## SYDNEY CENTRAL CITY PLANNING PANEL

### COUNCIL ASSESSMENT REPORT

<b>Panel Reference</b>	PPSSCC-170
<b>DA Number</b>	DA/716/2020
<b>LGA</b>	City of Parramatta Council
<b>Proposed Development</b>	Lot consolidation, demolition and construction of a 26 storey mixed-use development comprising 2 retail tenancies on the ground floor, 3 levels of podium car parking comprising 86 car spaces and 114 residential units above. The application is Nominated Integrated Development under the provisions of the Water Management Act 2000. The application will be determined by the Sydney Central City Planning Panel.
<b>Street Address</b>	38-42 East Street, GRANVILLE NSW 2142
<b>Applicant/Owner</b>	Toplace Pty Ltd
<b>Date of DA lodgement</b>	18 November 2020
<b>Number of Submissions</b>	One (1) submission
<b>Recommendation</b>	Refusal
<b>Regional Development Criteria (Schedule 4A of the EP&amp;A Act)</b>	General Development Over \$30 Million Cost of Construction proposed = \$40,479,152.00

Figure 3: Survey Plan – red notation denotes railway land/asset

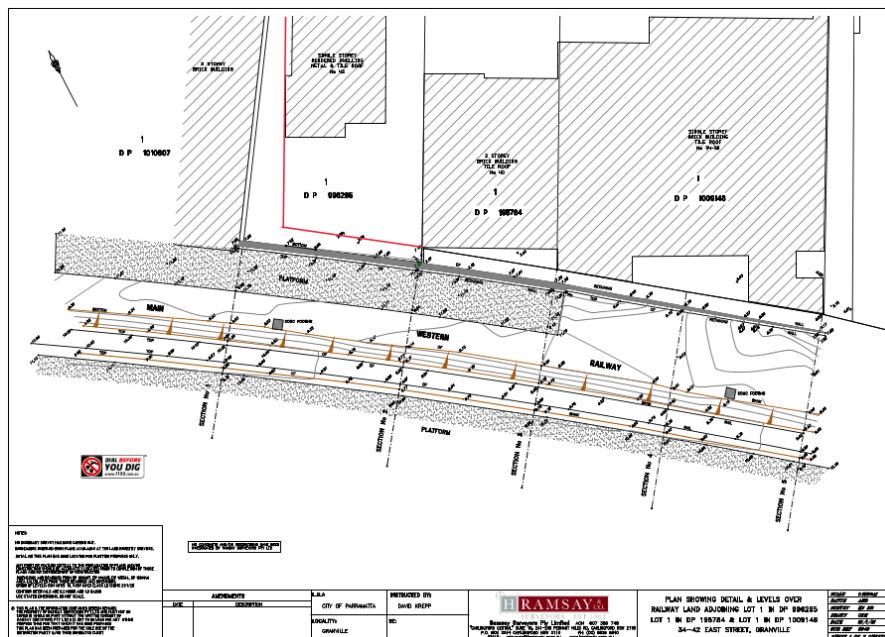
Sydney Trains have raised concerns over a discrepancy between the applicant's survey plan and information from Sydney Trains. Sydney Trains notes that a portion of the subject site that is shared by the railway land to the north-west is part of the Sydney Trains asset site. See image below.

Sydney Trains has requested the applicant's surveyor review and properly survey any encroachments and prepare a new survey plan that can be relied upon and included on all DA drawings.

Given the extent of the encroachment on railway land, it is likely that the proposal would require a significant redesign.
